TOC Reference Number: CRN 21-026**Expiry Date: 22 November 2021****Distributed to:** Internal TOC Waiver Distribution List
External TOC Waiver Distribution List**Issued by:** Drew Palmer**Requested by:** Principal Track & Civil Engineer**Issued Date:** 21 May 2021**Start Date:** 22 May 2021

Subject: Infrastructure Changes – near Polona

This TOC Waiver is updating the network configuration in the proximity of Polona.

TRACK DIAGRAM - Bowenfels (excl) to Dubbo (excl) (290km - 320km)

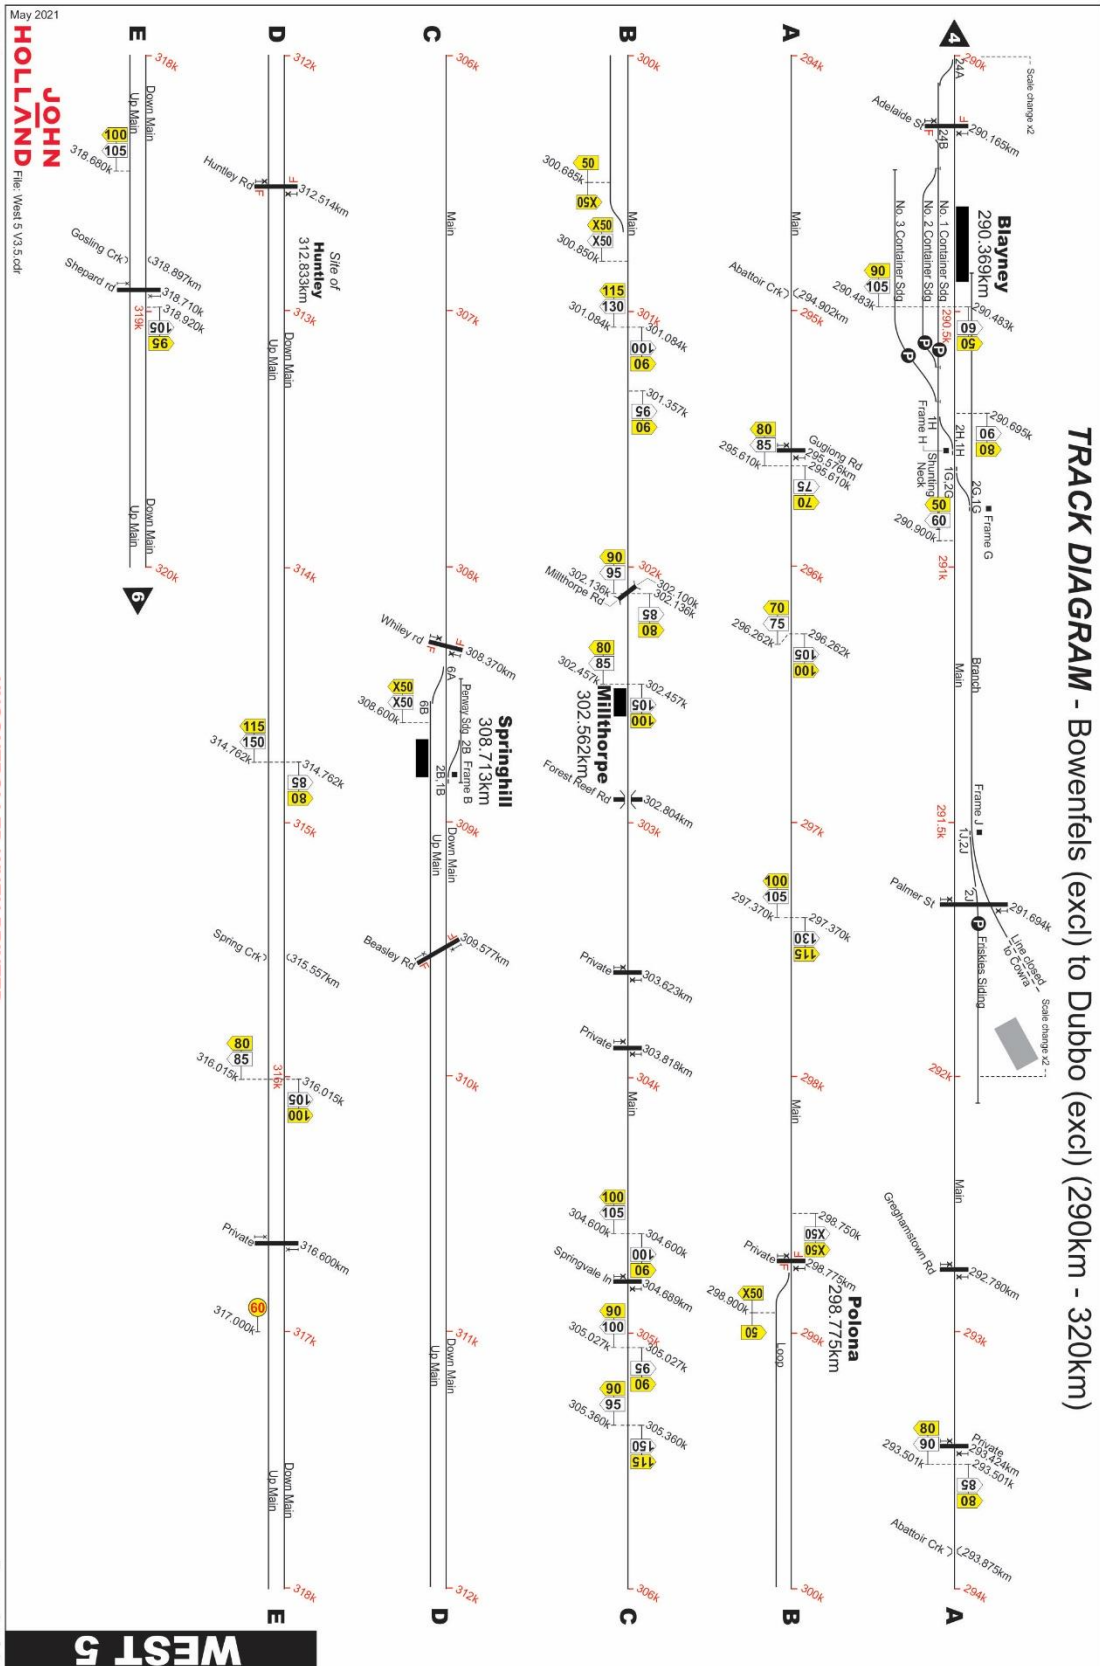
Changes made include:

- Level Crossing at 298.770km upgraded to F type (active)
- Polona 52 points relocated to 300.801km
- Train Capacity for the Loop Road at Polona increased to 1,807m
- Speed Board changes listed below:

Western Section Diagrams – Bowenfels ↔ Dubbo

1. Km 298.750	DN Normal	X50 sign unchanged		
	DN XPT	X50 sign added		
2. Km 298.775			UP Normal	CLCS 20 removed
3. Km 299.990	DN Normal	X50 sign removed		
4. Km 300.850			UP Normal	X50 sign added
			UP XPT	X50 sign added

Western Section Diagrams – Polona

5. Km 298.900	DN Normal	50 sign added	UP Normal	X50 sign added
6. Km 300.685	DN Normal	X50 sign added	UP Normal	50 sign added
